### **Hope Creek ODCM Rev 24**

# OFFSITE DOSE CALCULATION MANUAL

HOPE CREEK GENERATING STATION

Revision 24

FIGURE E-1: ONSITE SAMPLING LOCATIONS

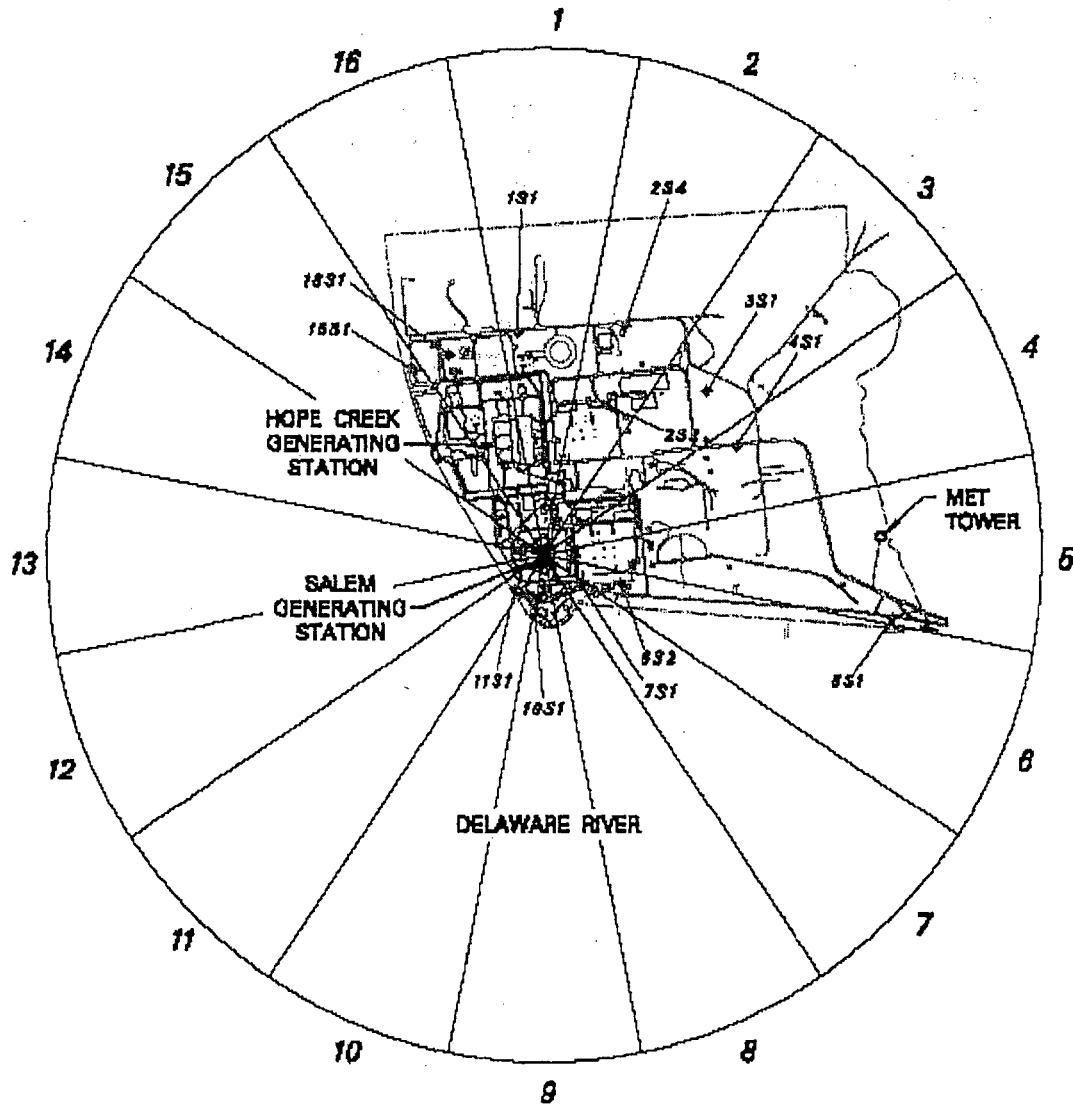
3. Updated Figures E-1 On-site Sampling Locations and E-2 Off-site Sampling Locations to update the new sampling locations.

**Justification:** The maps were updated to be consistent with the REMP station locations listed in Table E-1.
